St. Lucie Unit 1
Docket No. 50-335
Proposed License Amendment
RCS Pressure/Temperature Limits

ATTACHMENT 4

ST. LUCIE UNIT 1 MARKED-UP TECHNICAL SPECIFICATION PAGES

FIGURE 3.1-1b
 MAXIMUM ALLOWABLE HEATUP AND COOLDOWN RATES,
 SINGLE HPSI PUMP IN OPERATION

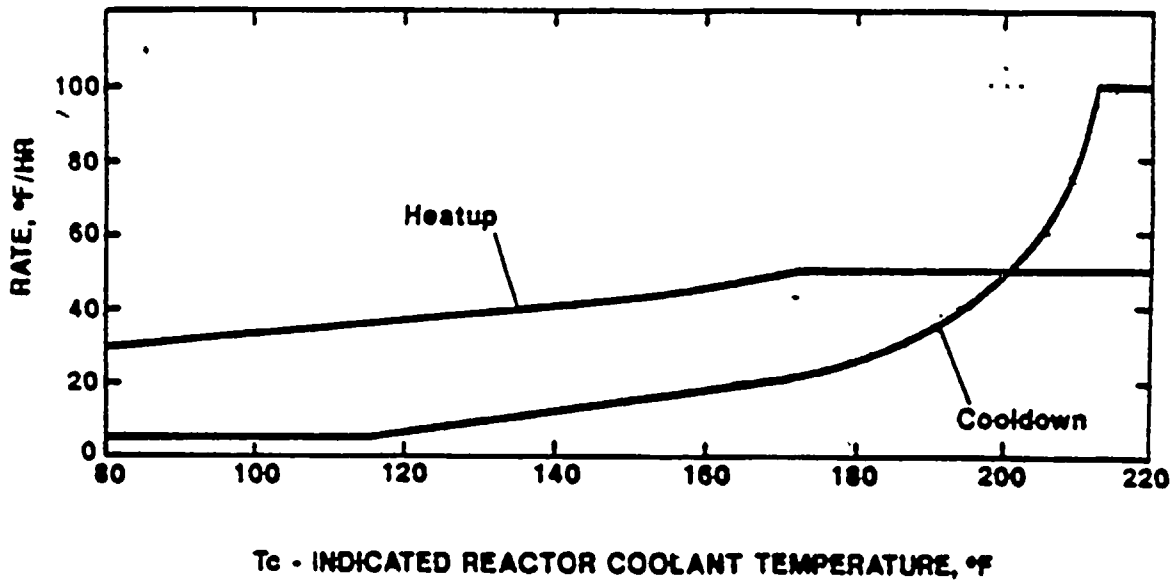
(23.6 EFPY)

ADD

(53.6 EIPPY)

FIGURE 3.4-2b
 ST. LUCIE UNIT 1 P/T LIMITS, 15 EPFY
 COOLDOWN AND INSERVICE TEST

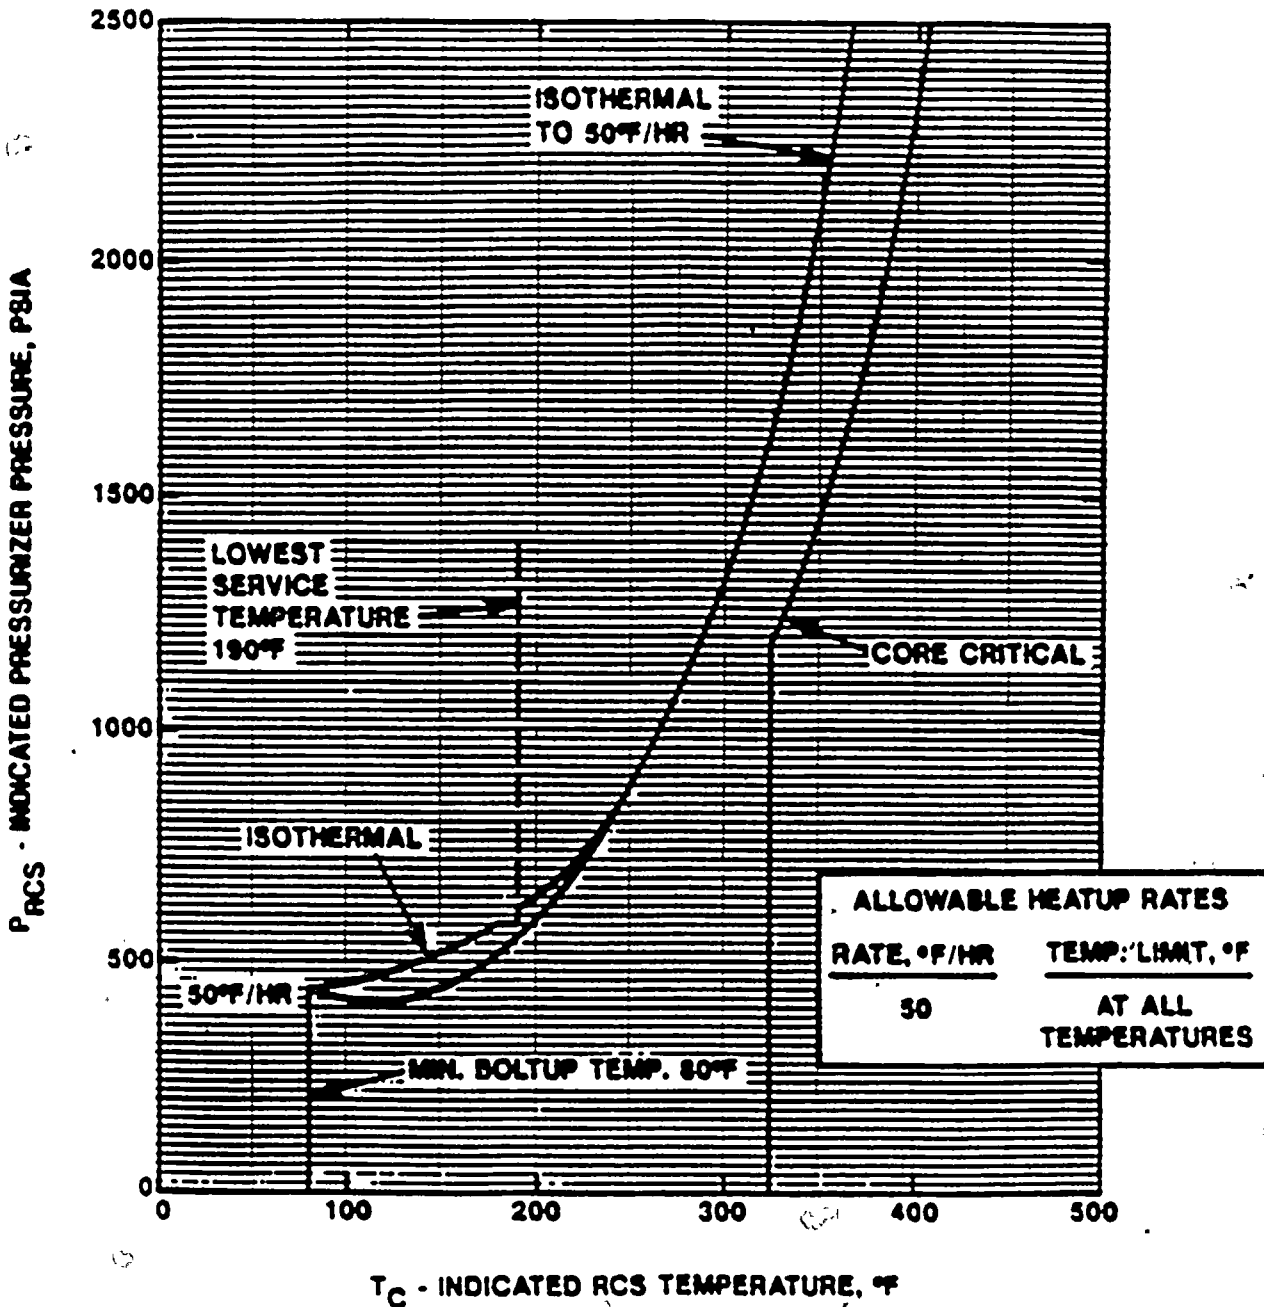
INSERT

23.6

FIGURE 3.4.3
ST. LUCIE UNIT 1, 85 EFPY
MAXIMUM ALLOWABLE COOLDOWN RATES

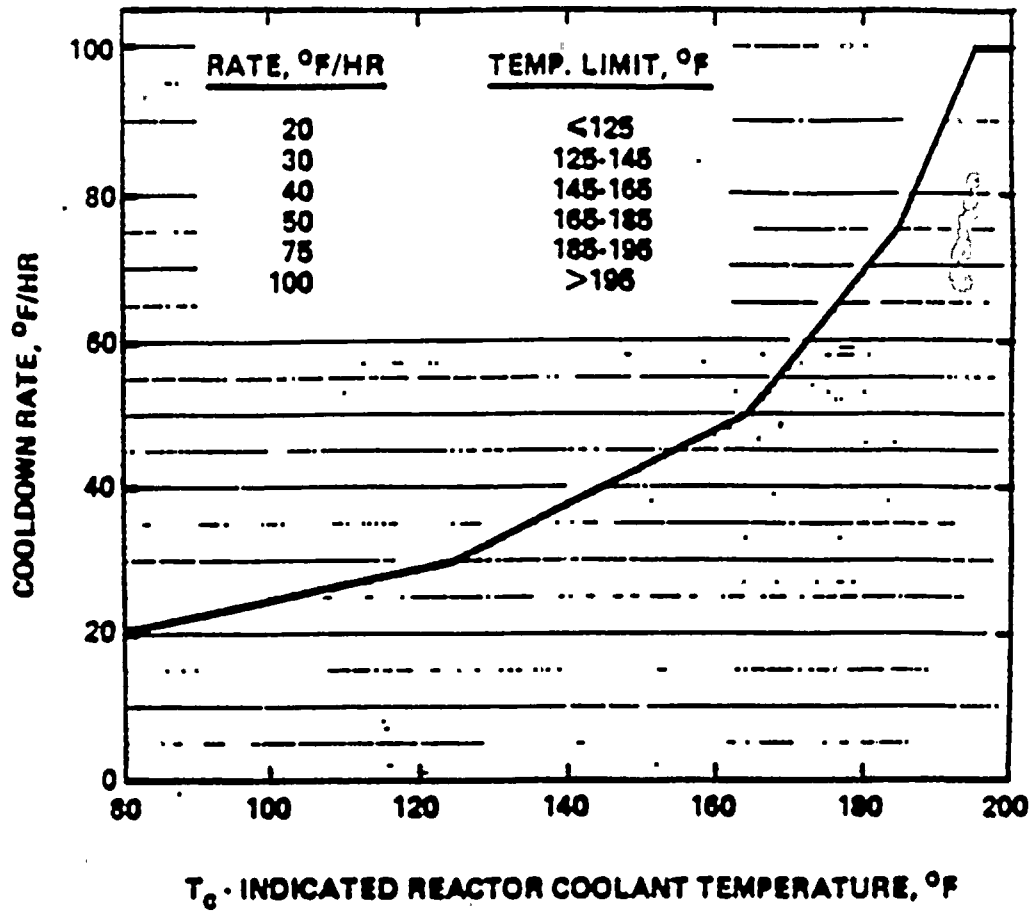
INSERT 23.6
